FINAL
ANNUAL REPORT AND YEAR THREE REVIEW
FOR THE ASH LANDFILL OPERABLE UNIT
SENECA ARMY DEPOT ACTIVITY

Contract No. W912DY-08-D-0003
Task Order No. 0001
EPA Site ID# NY0213820830
NY Site ID# 8-50-006

RESPONSE TO COMMENTS

Army's Response to Comments from the United States Environmental Protection Agency

SENECA ARMY DEPOT ACTIVITY
ASH LANDFILL
ASH LANDFILL ANNUAL REPORT
FIGURE 1
ASH LANDFILL LOCATION AT SEDA
August 2010

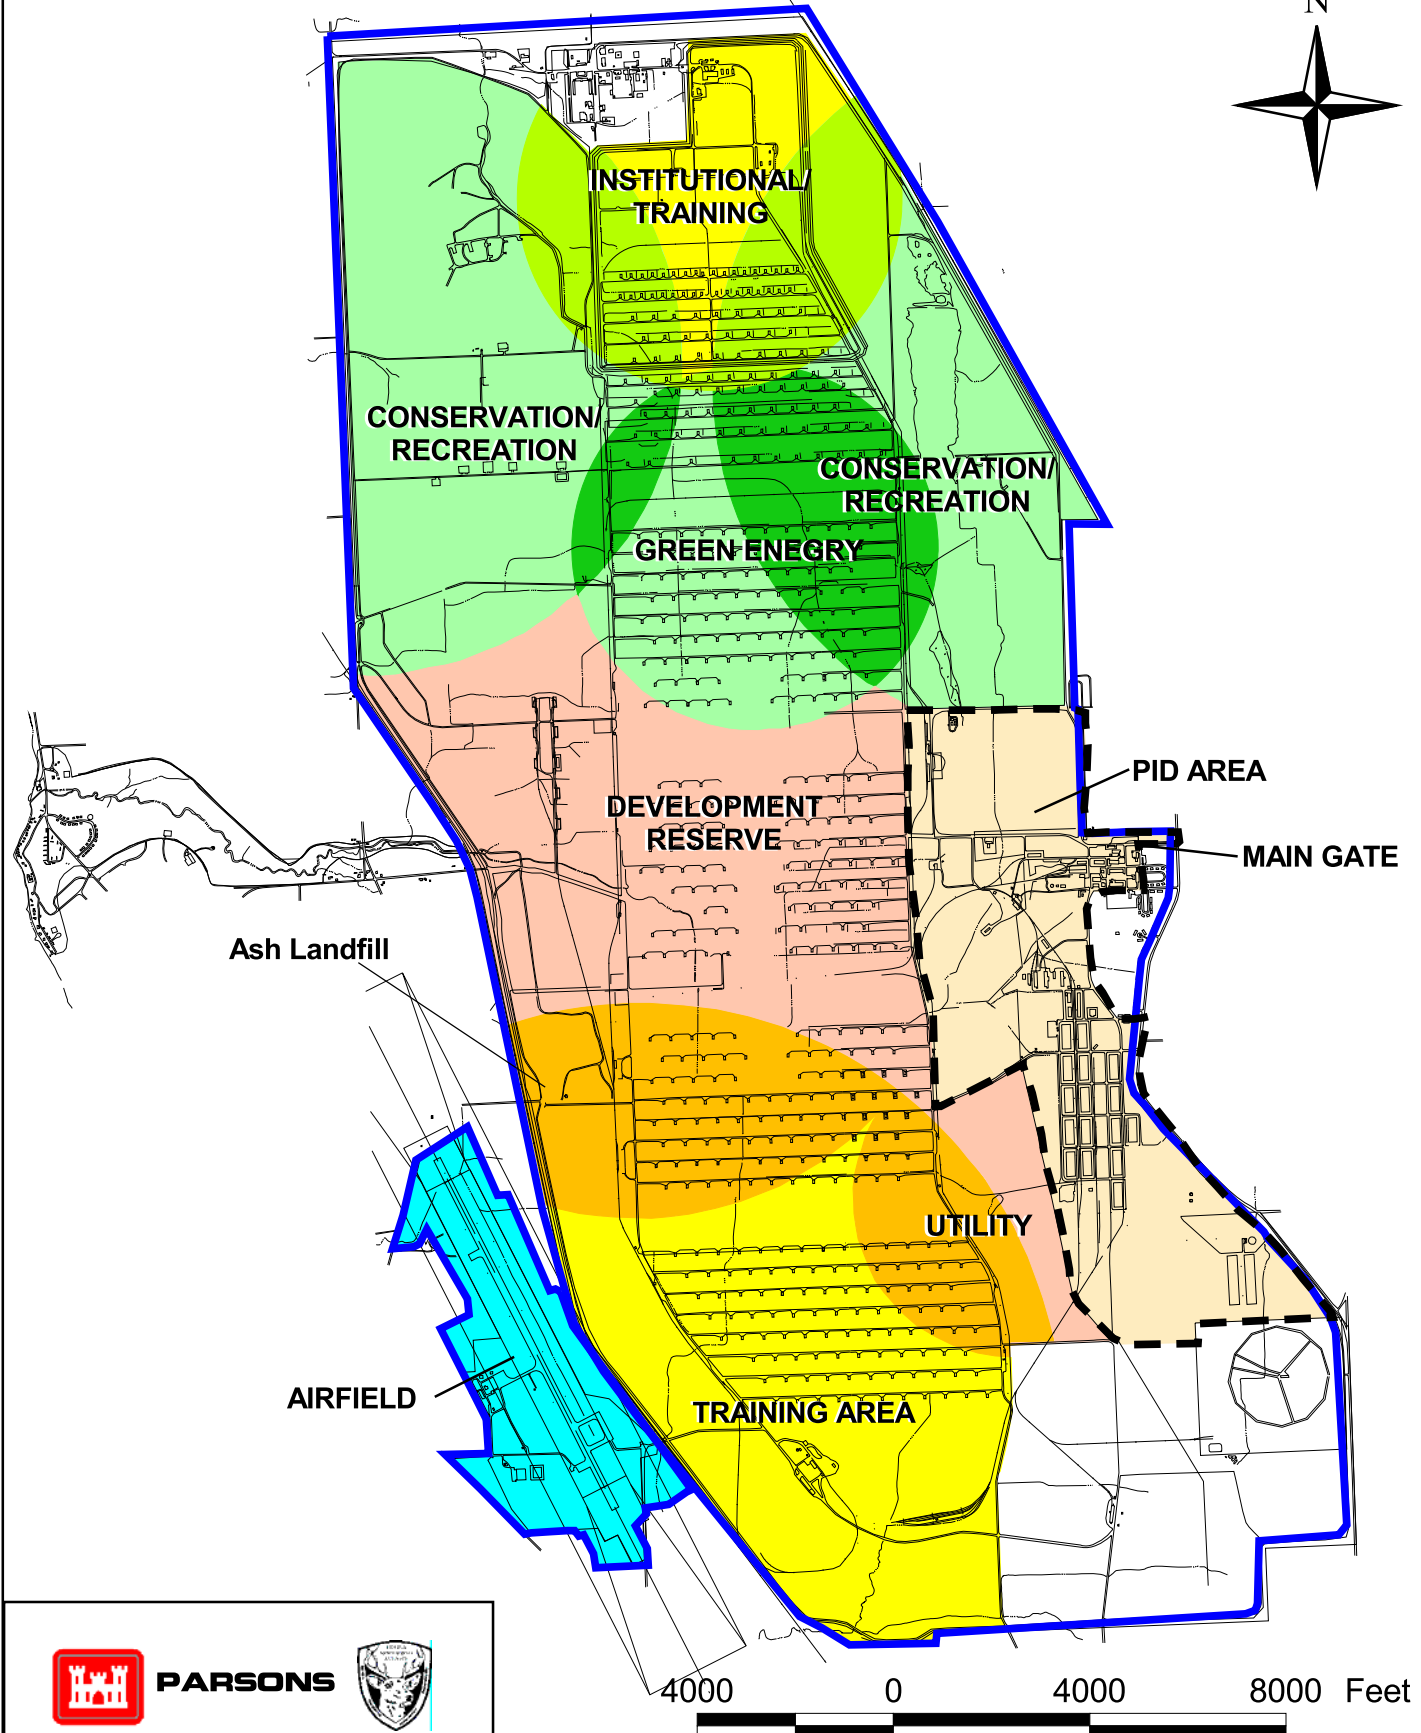
Comment 2: The Annual Report does not provide a general location map for the Seneca Army Depot Activity (SEAD). In addition, none of the figures included in the report show the SEDA site boundaries. As on-site and off-site wells are discussed in the Annual Report for the Ash Landfill Operable Unit (OU), it is important to show the site boundary lines so an evaluation of the detected concentrations in groundwater in relation to off-site areas can be conducted. Revise the Annual Report to include a general location map for SEDA. Further, clearly designate the SEDA site boundaries on all applicable figures, and ensure that the farmhouse wells reportedly located within 1,250 feet of the leading edge of the contaminant groundwater plume are shown on the figures.

Response 2: A figure showing the location of SEDA has been added as Figure 1. Subsequent figure numbers have been updated to reflect the addition of this figure. The SEDA site boundary has been added to all figures showing the site. The farmhouse wells are located at a significant distance from the center of the plume; including them on each figure would significantly alter the scale of each drawing so that the locations of the biowalls and the LTM monitoring wells would be difficult to view on the figure. As such, a new figure showing the location of the farmhouse in relation to the OU has been added as Figure 4.

FIGURE 3
 ASH LANDFILL
 HISTORIC SITE MAP

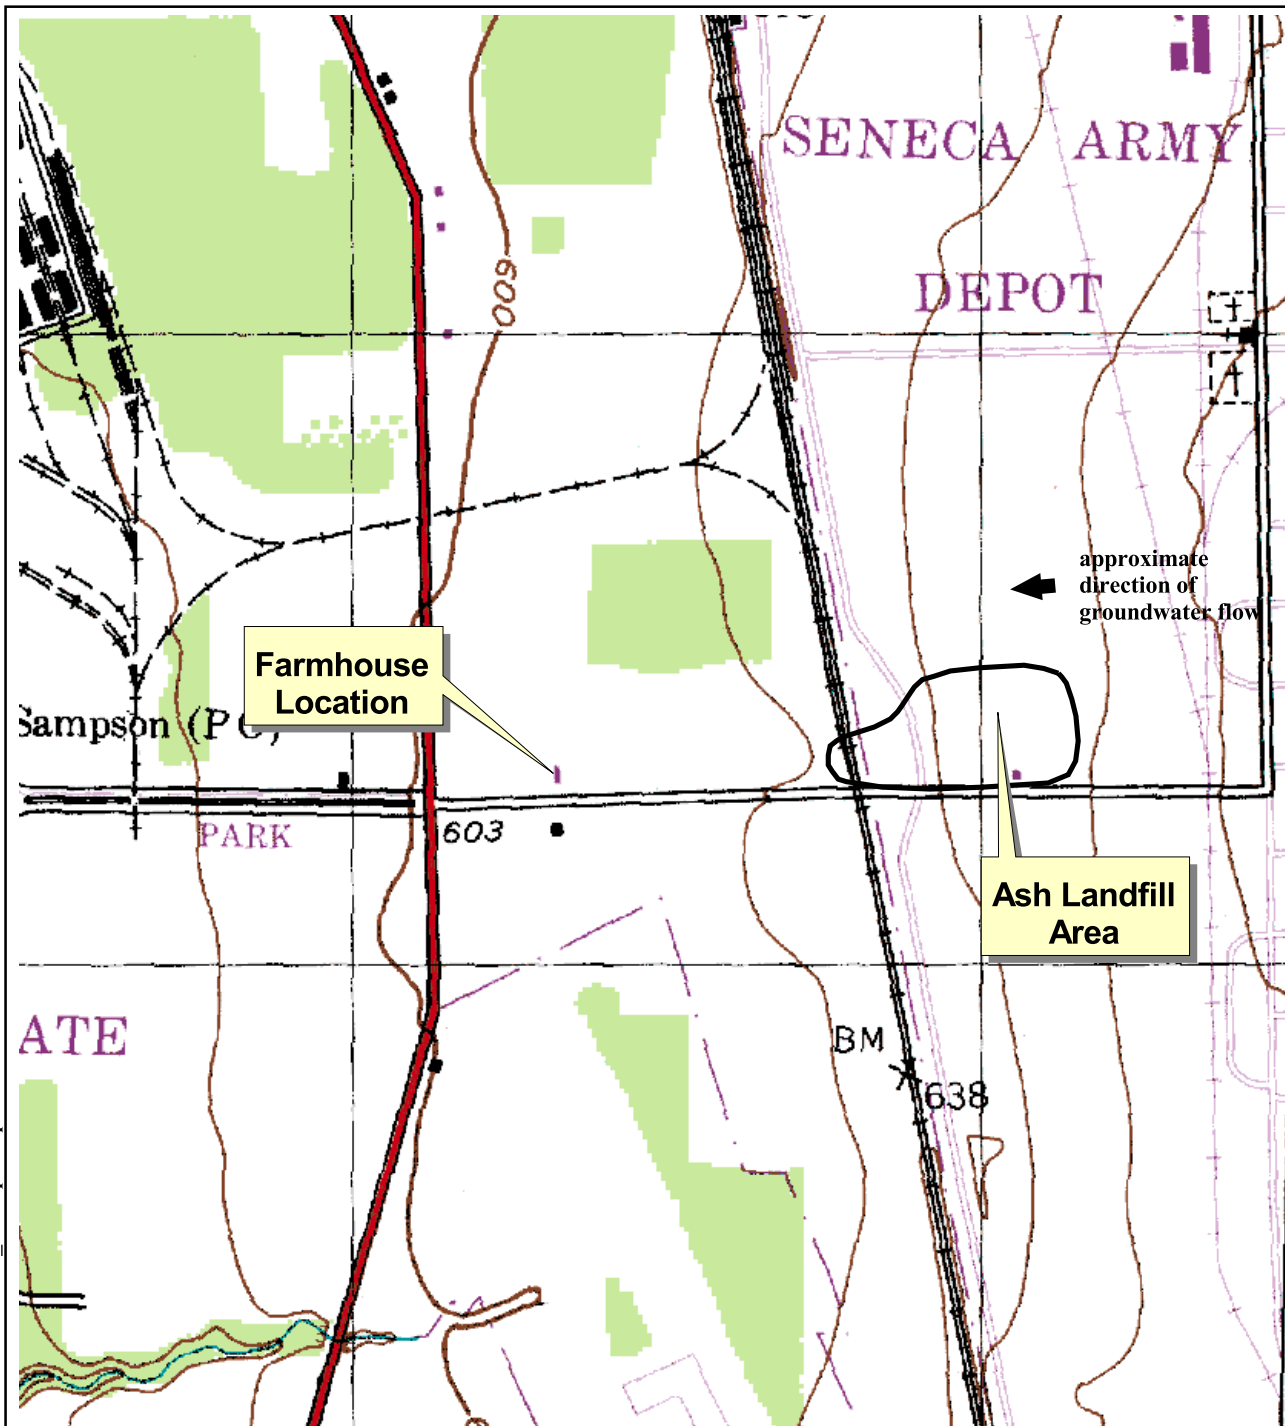
Comment 2: Section 2.3, Soil and Groundwater Impacts, Page 5. This section describes a Non-Time Critical Removal Action (NTCRA) conducted in an area northwest of the Ash Landfill. The Annual Report states that this area is believed to have been the source of the groundwater plume. The limits of this excavation are not shown on a site figure. However, the initial source area/excavation area should be presented on a site figure to show the relationship between the initial source area and the current extent of groundwater contamination, especially given the lack of definitive trends in some of the monitoring data. Revise the Annual Report to include the excavation limits from the NTCRA on a site figure in relation to the existing groundwater plume.

Response 2: Figure 3 shows the limits of the NTCRA, referenced as the "Approximate Extent of IRM Treatment." The legend on Figure 3 has been revised to indicate "Approximate Extent of NTCRA Excavation and IRM Treatment". The text on page 5 has been updated to reference Figure 3.

**FIGURE 6
CHLORINATED ETHENE CONCENTRATIONS
IN GROUNDWATER**

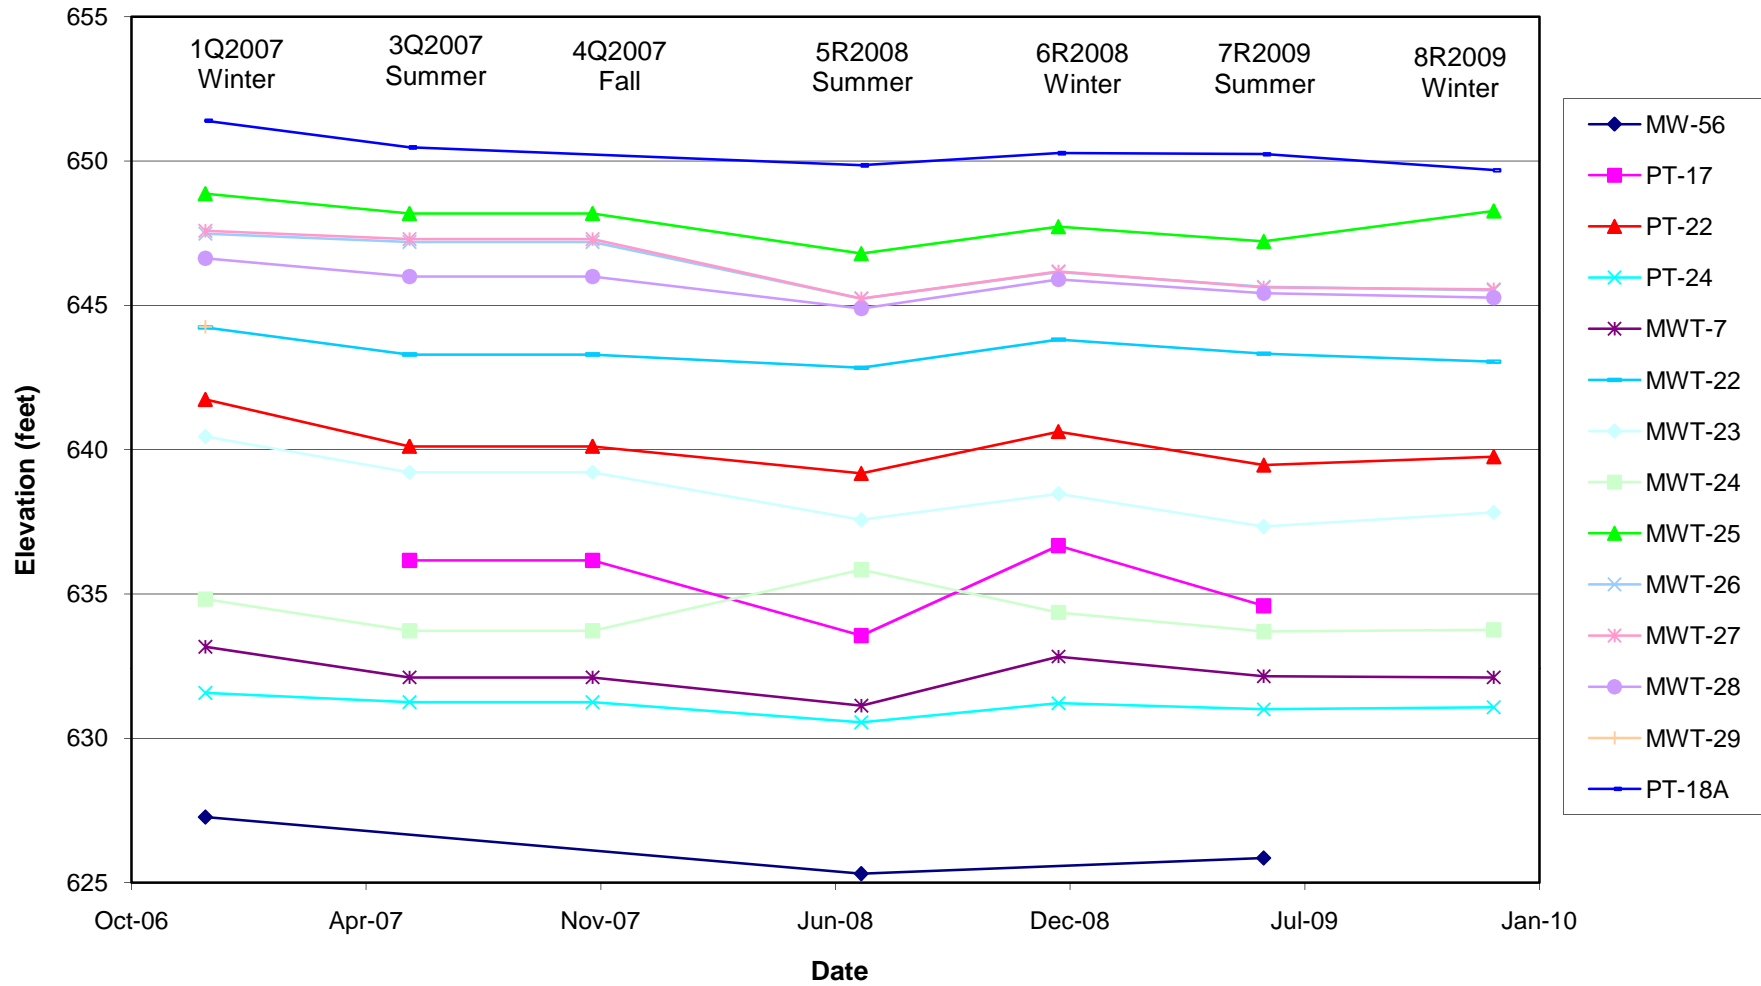
Comment 3: Figure 4, Chlorinated Ethene Concentrations in Groundwater, shows groundwater isocontours, but it is unclear for what constituent(s) these contours apply (i.e., TCE, all chlorinated volatile organic compounds [VOCs], etc.) In addition, the legend of Figure 4 indicates that these isocontours are constructed using data from January 2000. Recent groundwater data should be used to show the current configuration of the groundwater plume. Revise the Annual Report to include a figure that shows the current configuration of the plume, with the constituents represented by the isocontours clearly defined, or alternatively, provide seasonally-based isocontours that could assist in the assessment of the plume's leading edge flow direction.

In addition, it is not apparent from the plume configuration presented on Figure 4, Chlorinated Ethenes Concentrations in Groundwater, that the off-site sentry well, MW-56, will be appropriate to detect concentrations of contaminants migrating from MWT-7 at which vinyl chloride was detected at 21 ug/l, (and order of magnitude above the NYSDEC Class GA Groundwater Standard of 2 ug/l). A well located downgradient the leading edge of the plume, in a trajectory that is consistent with the highest concentrations detected, should be considered to ensure that contaminants detected above the remedial goals are not bypassing the existing monitoring network to the south of well MW-56, and migrating off-site at potentially unacceptable levels.

Response 3: Isocontours provided in former Figure 4, now referenced as Figure 6, were constructed using total chlorinated ethenes concentrations collected at the Ash Landfill from a January 2000 sampling event. The current biowall LTM program, as approved in the RDR, monitors groundwater conditions at wells located generally along the centerline of the historic plume. As a result, the current data from the biowall LTM program do not provide sufficient coverage to characterize the current shape of the plume, since information about the lateral extent of the plume is not available. The most recent round with sufficient data to develop isocontours is from the August 2004 sampling event completed prior to installation of the biowalls. The figure has been revised and the 2000 plume depiction is replaced with isocontours of total chlorinated ethenes based on August 2004.
